Subject: Indian Point 3 Nuclear Power Plant
Docket No. 50-286
Additional Information Related to NUREG-0737, Item II.D.1;
Pressurizer Safety and Relief Valves (PRZR. S/RVs) Testing

RESPONSE TO NRC 6/6/85 REQUEST
FOR ADDITIONAL INFORMATION
REGARDING
NUREG-0737, ITEM II.D.1
PERFORMANCE TESTING OF PRESSURIZER
SAFETY AND RELIEF VALVES

NEW YORK POWER AUTHORITY
INDIAN POINT 3 NUCLEAR POWER PLANT
DOCKET NO. 50-286

FIGURE N^o 1

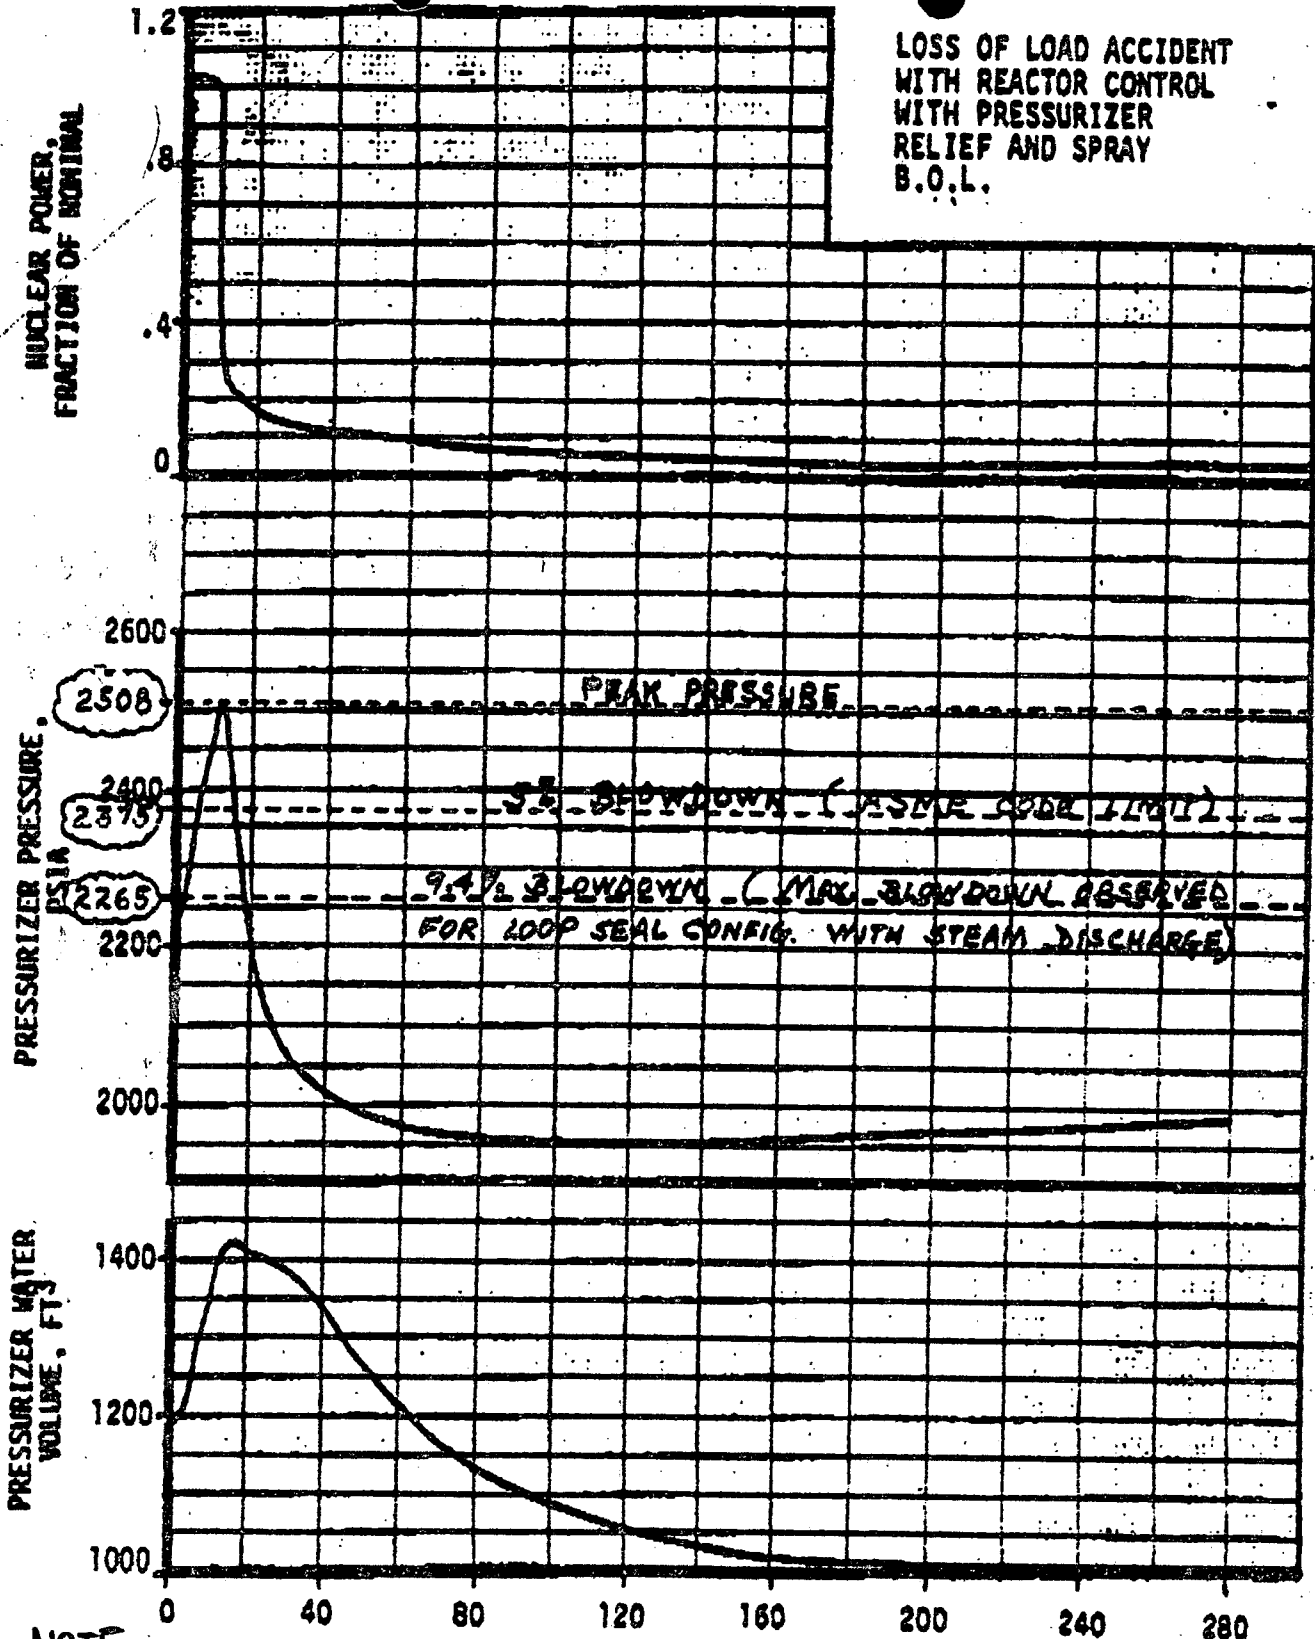
4. Results from the EPRI tests on the Crosby safety valves indicate that the test blowdowns exceeded the ASME Code limit of 5% for both the "as installed" and "lowered" ring settings. If the blowdowns expected for Indian Point 3 also exceed 5%, the higher blowdowns could cause a rise in pressurizer water level such that water may reach the safety valve inlet line and result in a steam-water flow situation. Also the pressure might be sufficiently decreased such that adequate cooling might not be achieved for decay heat removal. Discuss these consequences of higher blowdowns if increased blowdowns are expected.

Since the EPRI safety valve tests are applicable to the IP-3 valves, there is no reason to expect blowdowns different from the test results. Therefore, blowdowns ranging from 5.1 to 9.4% can be expected for IP-3.

As stated previously in Reference 2 the only FSAR transient which challenges the safety valves is the "Loss of External Electrical Load". A review of this transient has been performed to evaluate the consequences of increased blowdown. It can be seen that the increased blowdown will not cause the pressurizer water level to reach the safety and relief valves inlet piping and will not reduce the pressurizer pressure below the minimum pressure established by the IP-3 FSAR analysis which is sufficient for adequate core cooling. This conclusion is based upon the FSAR transient response curves for the total loss of external load at beginning of life with zero moderator temperature coefficient assuming full credit for the pressurizer spray, PORV's and automatic control rod insertion but no credit for steam dump (see FIGURE 1). As seen from the pressurizer pressure transient curve, the pressure decreased below the minimum safety valve reseating pressure and, therefore, the increased blowdown is enveloped by the existing pressure curve. Furthermore, the water volume would actually decrease due to increased blowdown. The water volume in the pressurizer is reduced approximately 2% based on the additional time the safety valves are open and rated steam flow through the three safety valves.
